PRODUCT/PROCESS CHANGE NOTICE (PCN)

PCN #: A1910-01		DATE: 29-Oct-2019	MEANS OF DISTINGUISHING CHANGED DEVICES:	
Product Affected: FCCSP-53, FCCSP-253 (Refer to attachment II for affected part#)			☐ Product Mark	Traceable through lot#
			☒ Back Mark	
			☐ Date Code	
			☐ Other	
Date Effective: 29-Jan-2020				
Contact: PCN DESK	Attachment:		☒ Yes	☐ No
E-mail: idt-pcn@lm.renesas.com	Samples: N/A

ATTACHMENT I - PCN # : A1910-01

Assembly Sample Open/Short Test and 3-sigma Trigger Limit Disposition Flow

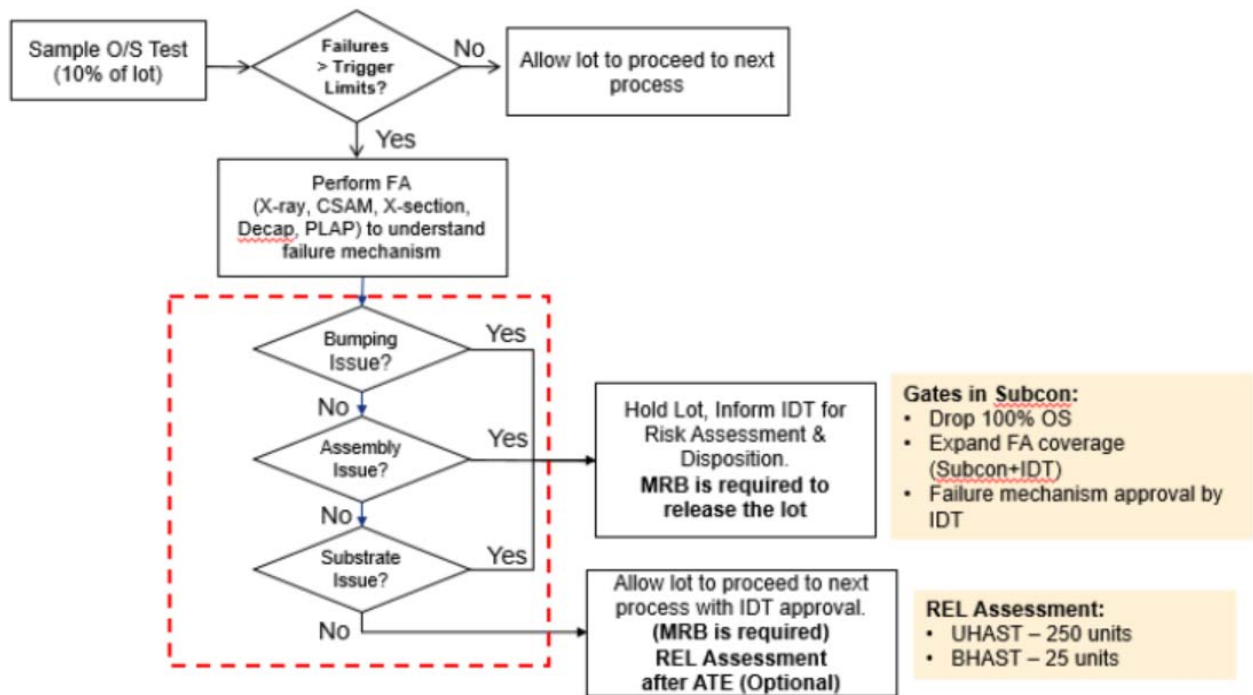
This notification is to advise our customers that Sample Open/Short test will be introduced at Assembly Process at Amkor Korea and Stats Chippac, Korea at the request of the customers.

Assembly process flow as detailed below.

Bumping Issue: Missing bumps, Open bumps, UBM Defects, RDL defects.

Assembly Issue: Bump bridge, Missing bump, Delamination, Die Crack.

Substrate Issue: Shorting Trace, Open Trace, Open Via.
